Independent Assessment of Duke Energy's Fast Track Review Process for DER Interconnection

Technical Update, October 2019

This report presents results from an independent, third-party review conducted by the Electric Power Research Institute of Duke Energy's Fast Track Review process as well as the accompanying technical criteria specified in the NCIP. A stipulation of the North Carolina Utilities Commission under Docket E-100 Sub 101 (Order Approving Revised Interconnection Standard and Requiring Reports and Testimony), this assessment evaluates both the need and grounds for implementing potential modifications to the existing Fast Track process.

Figure 4-1
Defined Line Sections on a Typical Feeder

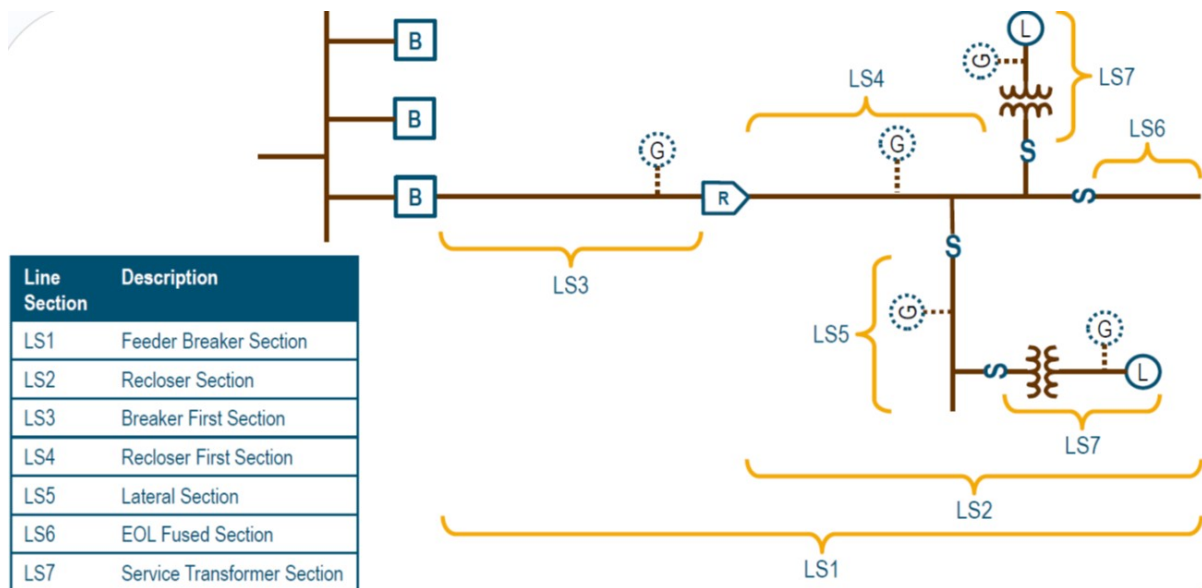
As described in the NCIP, the existing screen is consistent with industry practices and other jurisdictions. “Aggregate generation on any line-section, downstream of the next automation sectionalizing device,” is typical language used. The concept of “line section” can be a point of confusion because a wide variety of feeder configurations and “line sections” occur in many different forms.

As discussed in Chapter 3, the main objective of this screen is to avoid the possibility of islanding. A secondary objective for limiting DER to 15% of peak load is to avoid any impact on voltage regulation and quality. Regarding the unintended islanding objective, line sections of concern should only involve the one upstream automatic sectionalizing device and all downstream load and generation (only LS1, LS2, LS6, and LS7 in Figure 4-1).

Recommendation 3 – Duke should clarify how line sections are defined in screen 3.2.1.2 in its Method of Service and/or TIR document. This may be useful for informing customers and developers. When applying this screen in areas where the actual minimum load on the related section can be estimated, EPRI recommends using the estimate rather than the 15% proxy; this would need to include any load that may be masked by generation on a line section.

Figure 4-2
Unique Cases of Feeder Line-Sections where the Second Upstream Sectionalizing Device Defines the Aggregate Load and Generation on the Section

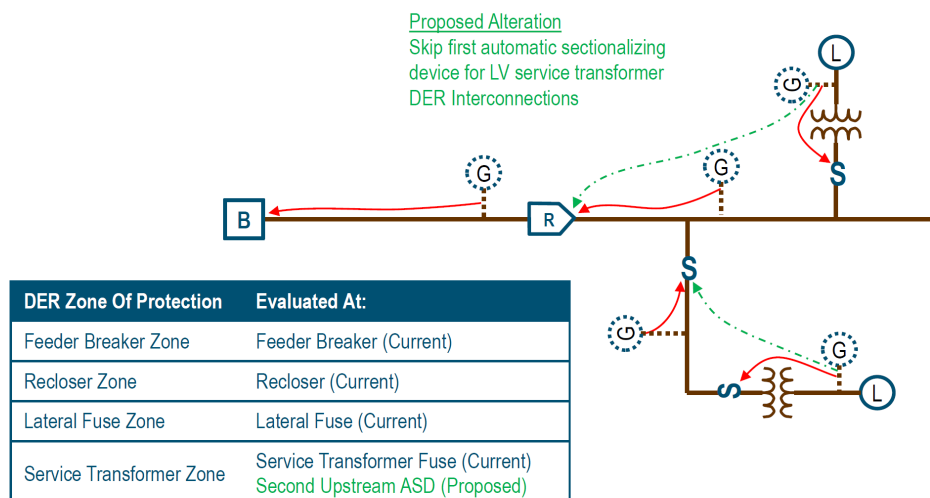
Further, there are updates and simplifications to Duke's current Supplemental Review shown in Figure 4-2. The figure illustrates two implementations of line sections. In the first case, the first sectionalizing device is a service transformer fuse and the second is a lateral fuse. In the second case, the first sectionalizing device is a service transformer fuse and the second is a recloser device on the mainline. In these cases, the second sectionalizing device is used to evaluate if the DER exceeds the 15% limit and if the protection is adequate.

Figure 4-3
Ground Fault Overvoltage when a DER Backfeeds into a Ground Fault

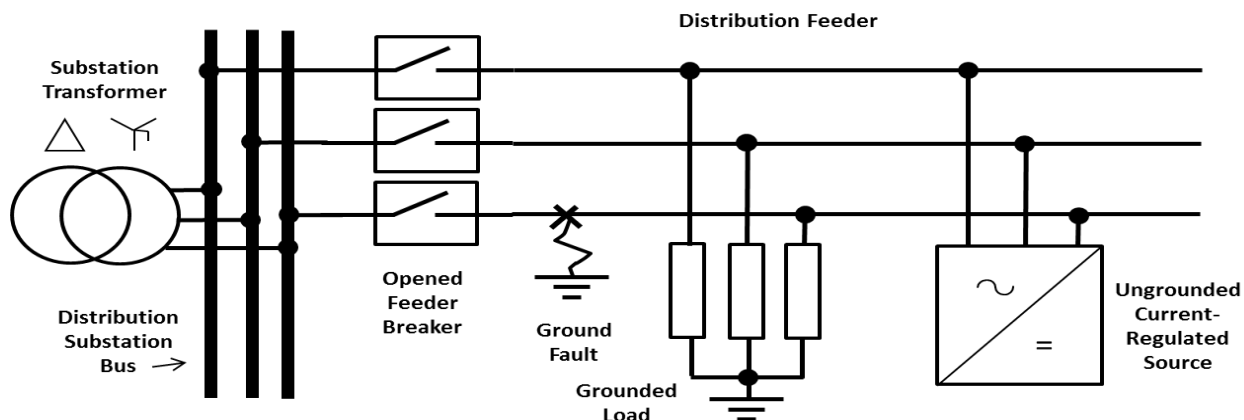
In the case of three-phase inverters, the issue of ground fault overvoltage is significantly mitigated, often reducing or eliminating the need to provide for effective grounding in the DER interconnection. On the other hand, if additional grounding is added with DER, there is a concern regarding side effects on protection coordination. Consequently, many distribution feeder designs require, and utility protection engineers prefer, interconnections that are not excessively grounded and/or the grounding is well-defined and can be considered in coordination of fault protection.

Currently, the NCIP screen implies that a three phase 4-wire feeder configuration, as is common in the Duke service territory, requires effective grounding to pass the screen. Duke's current practice for inverter-connected DER does not require or allow additional grounding in the plant interconnection or supplemental grounding in the plant. Depending on how it is interpreted, the existing screen may be inconsistent with the practice that developers see in other jurisdictions. That is, plants connected Yg-Yg require supplemental grounding or they will fail this screen.

Duke has recognized that supplemental grounding is likely not necessary for inverter connections. This is because a sufficient amount of line-to-ground connected load can effectively ground the system in the case of inverter-based DER. Just because the inverter does not itself provide the grounding does not mean that the condition does not exist. Effective grounding is a system characteristic, not a source characteristic.

Realizing this point is nontraditional, somewhat esoteric, and not easily understood, EPRI recommends making it clearer in the screen's pass/fail criteria. It should be clarified in applying screen 3.2.1.7 that PV inverters may be treated as exceptions to the need for local effective grounding. Again, effective grounding is a system issue, not a DER plant characteristic. The desired effective grounding comes about in a different way due to the strong effect of loads when considered relative to a current-regulated source, that is, in the case of inverters sources.
